**SECTION 000001 – ADDENDUM NUMBER 2**

**DATE: DECEMBER 8, 2025**

**RE: DCU CENTER ELEVATOR RENOVATION  
50 FOSTER STREET, WORCESTER, MA 01608**

Sheet Number: H101

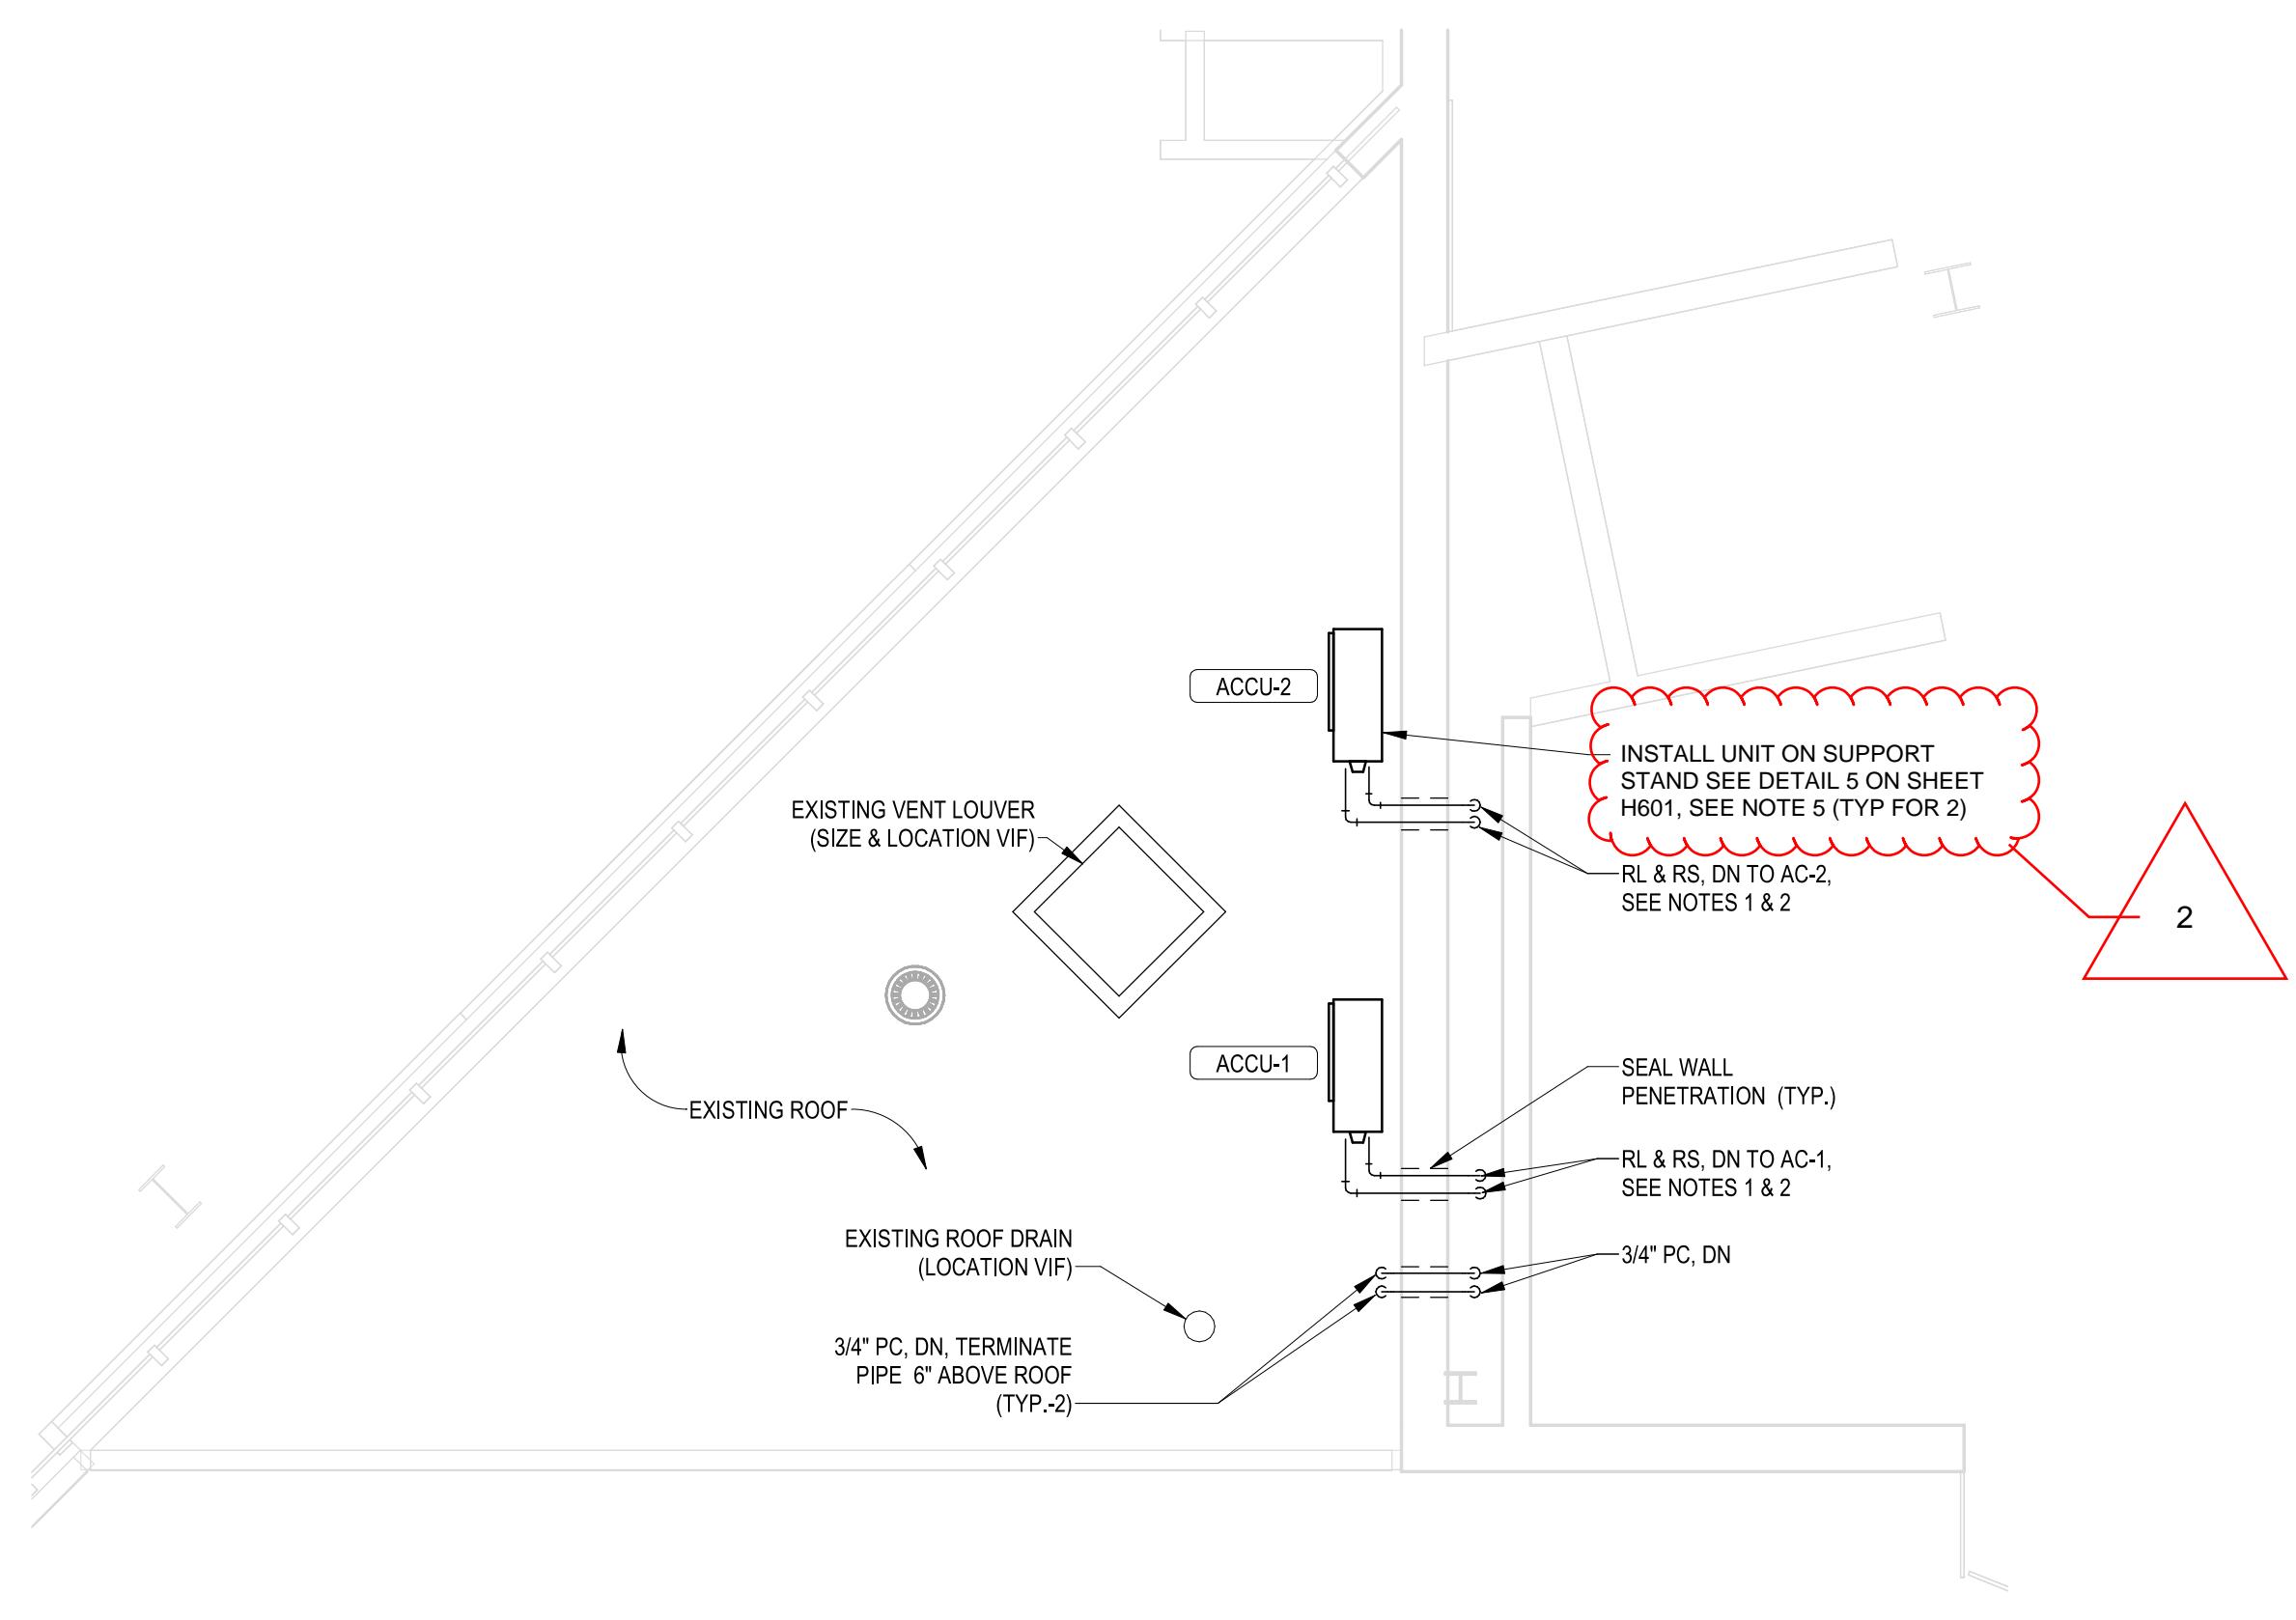
No. 2	Date 12/8/2025	Description new ACCU Mounted location on roof
-------	----------------	---

Drawing Title: HVAC DETAILS AND AUTOMATIC TEMPERATURE CONTROLS  
Sheet Number: H601

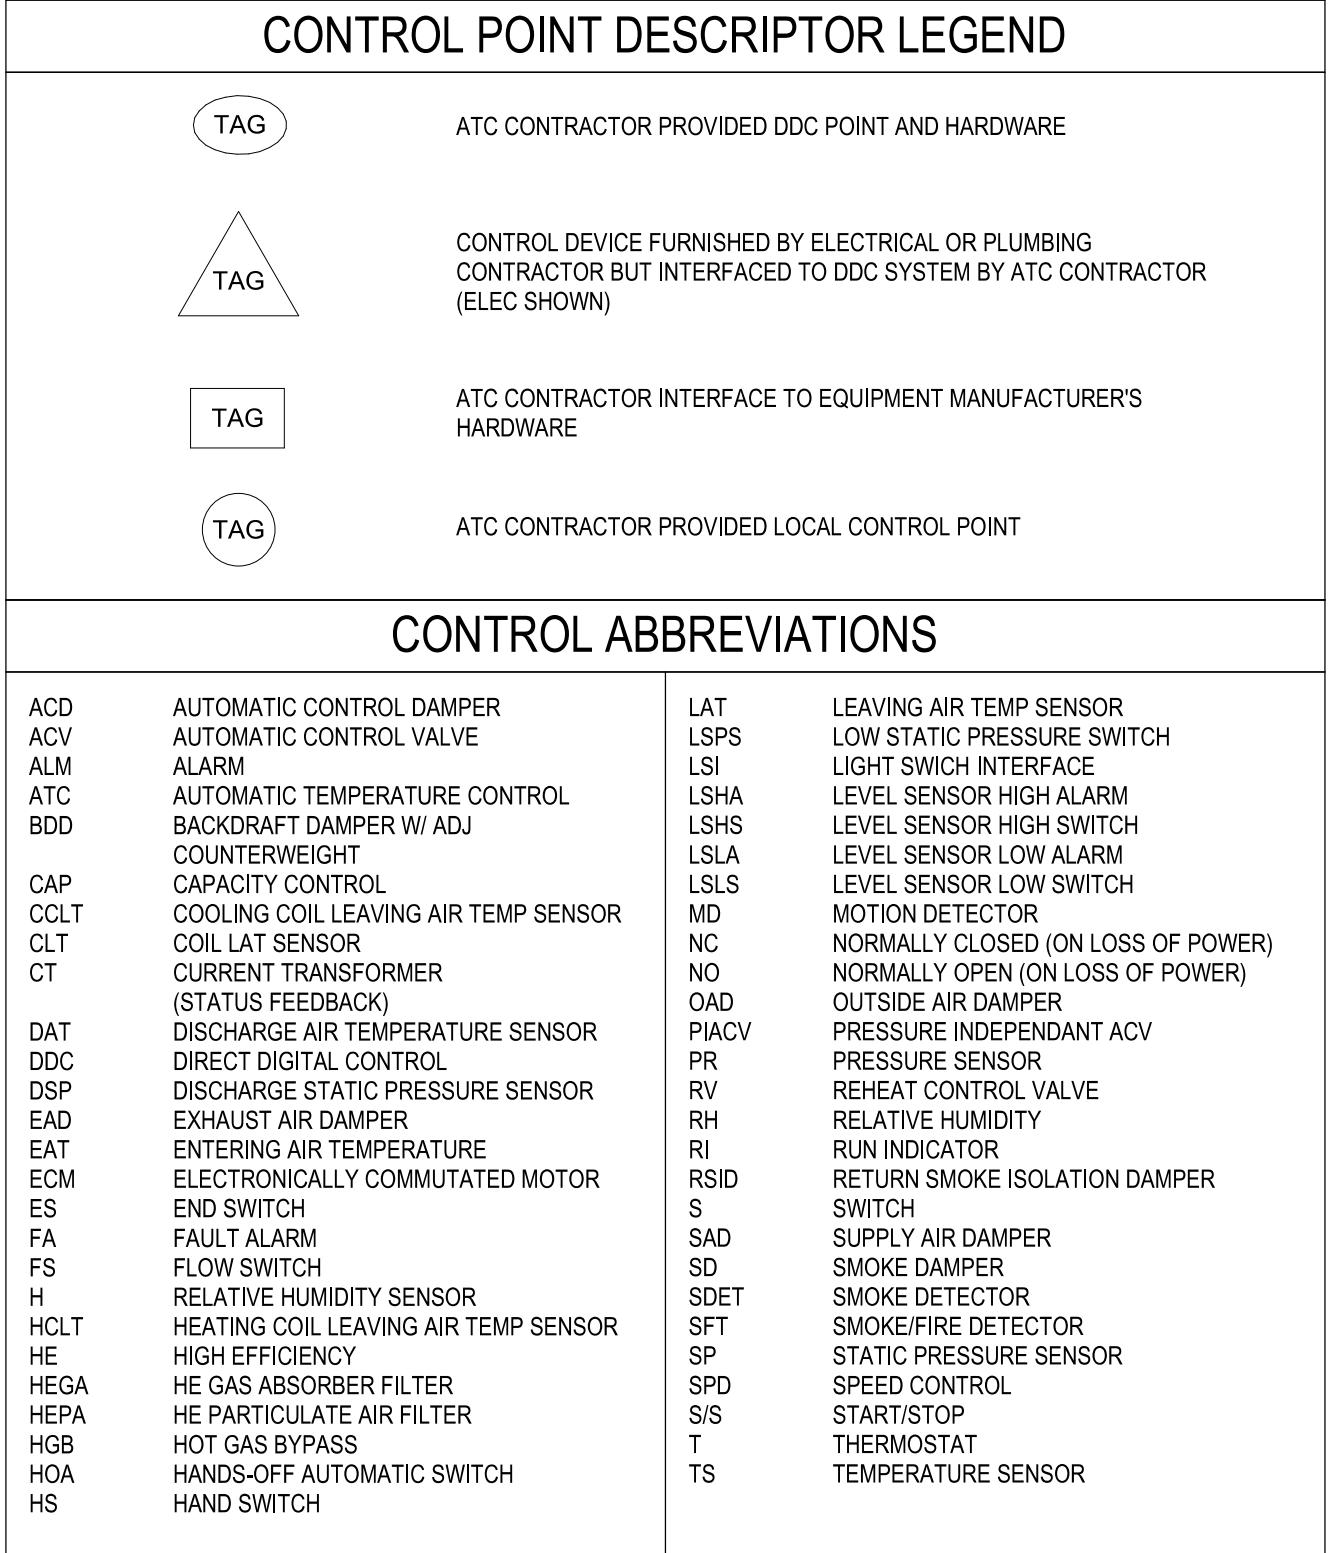
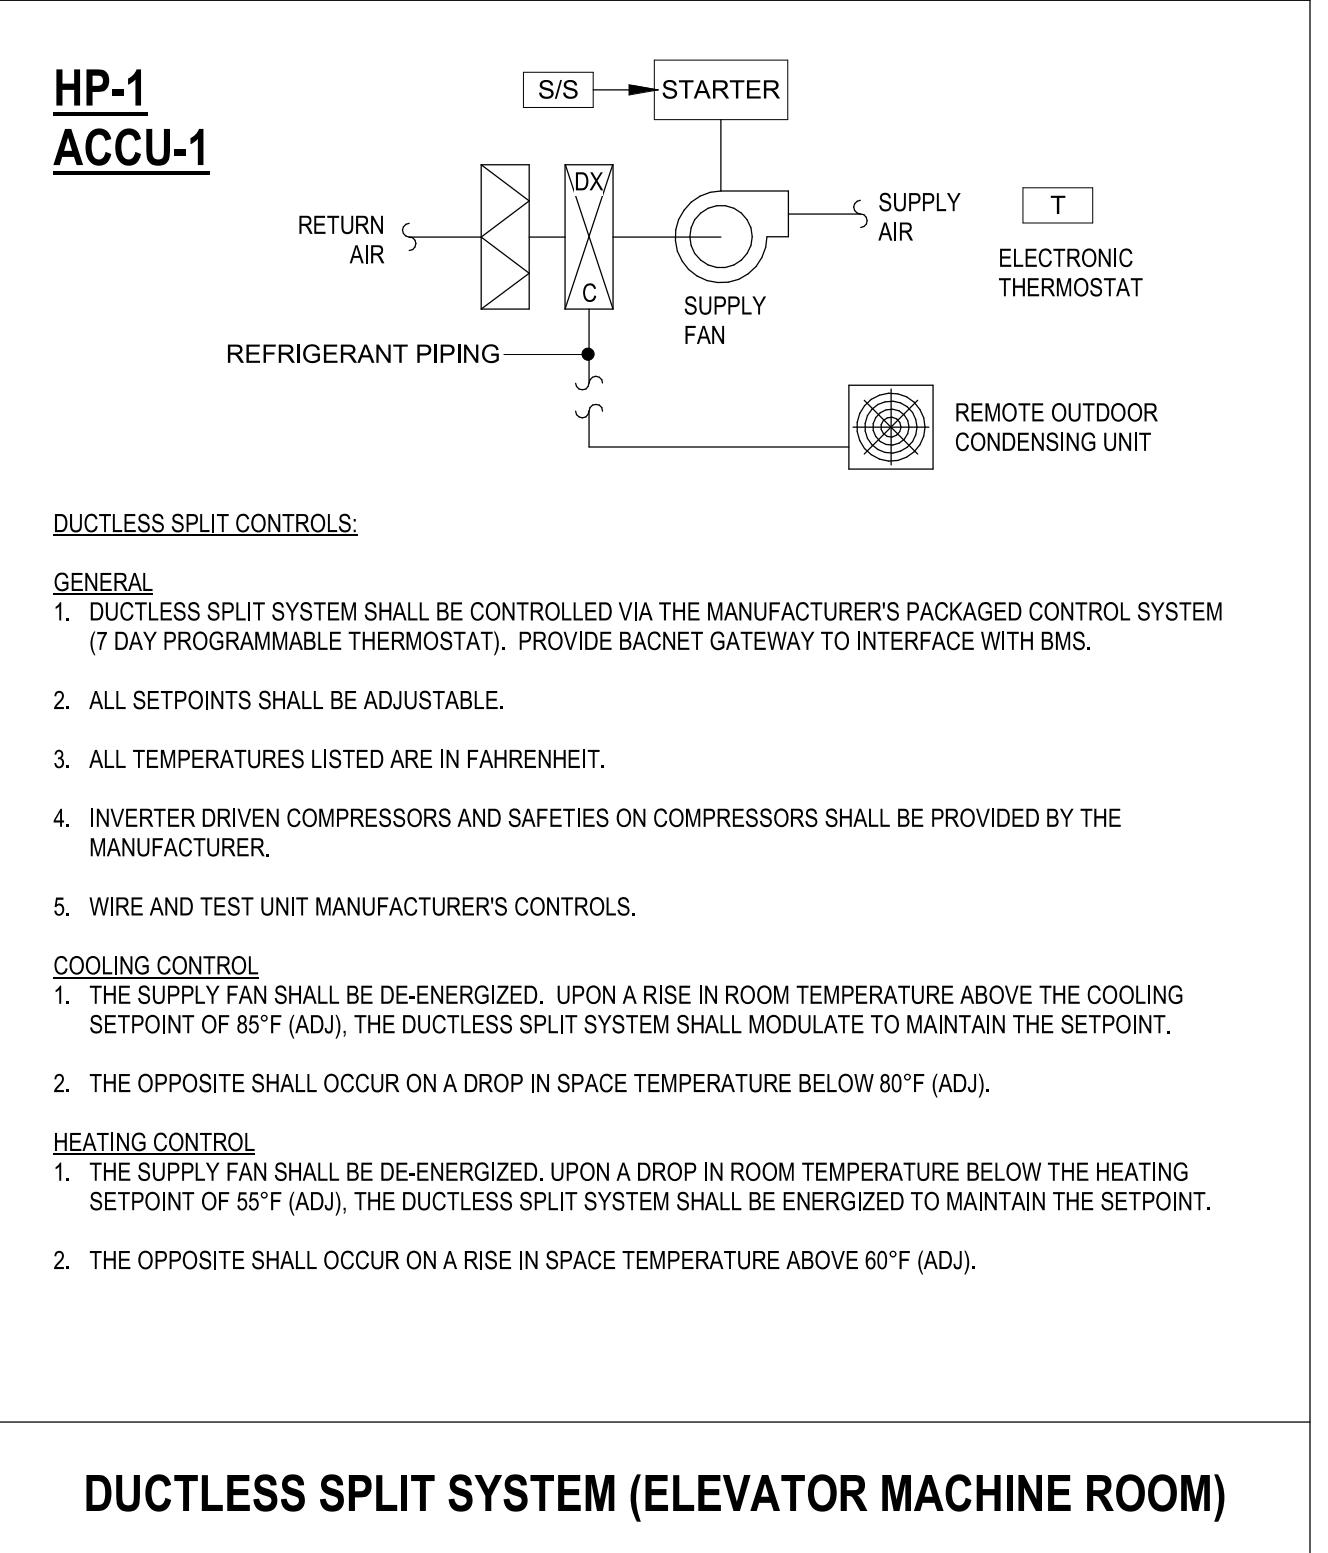
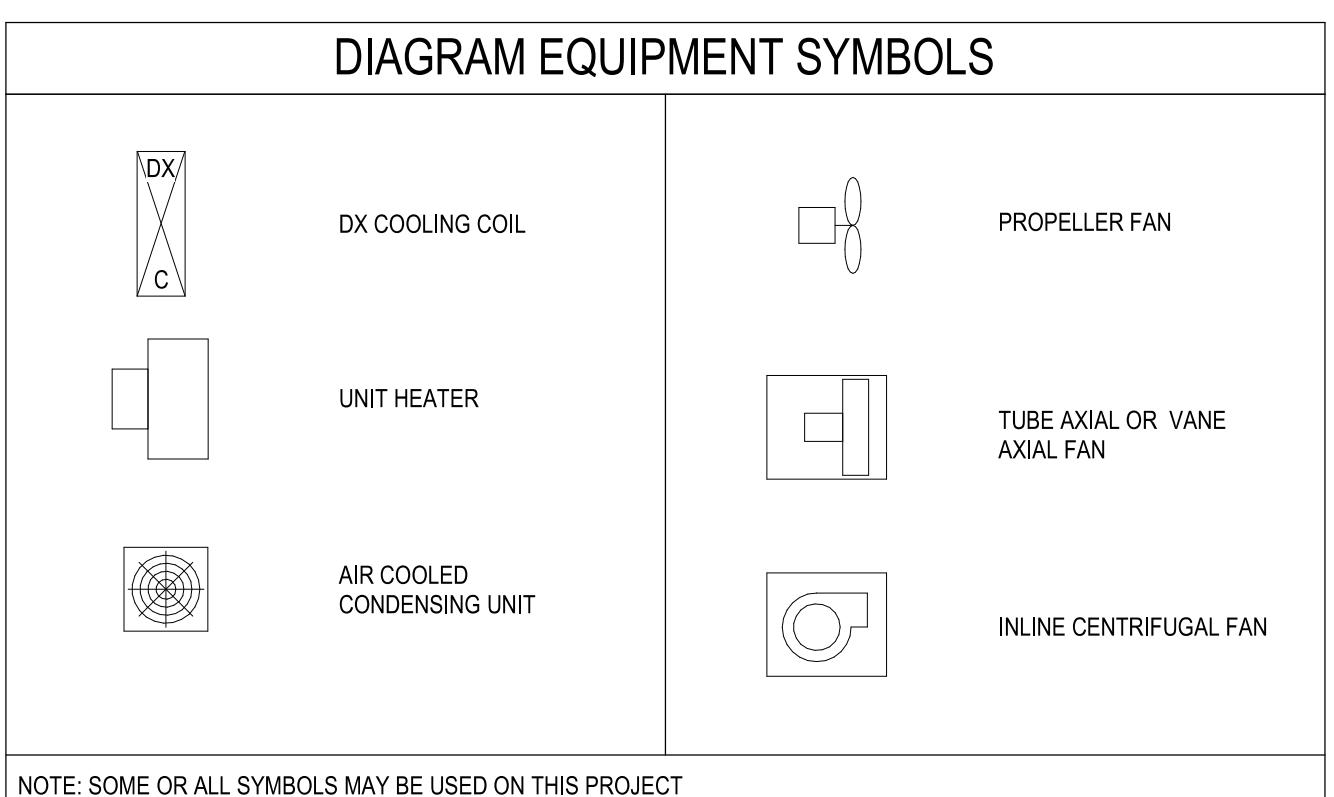
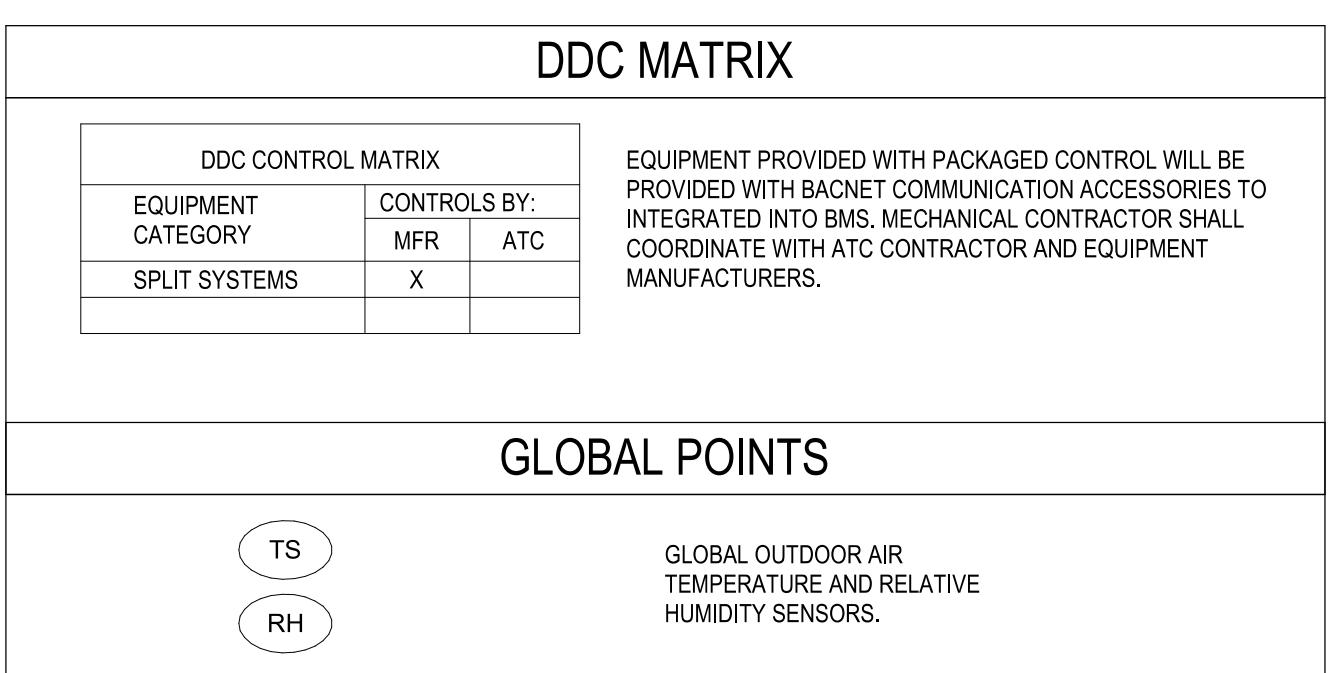
No.	Date	Description
2	12/8/2025	new ACCU Mounted location on roof
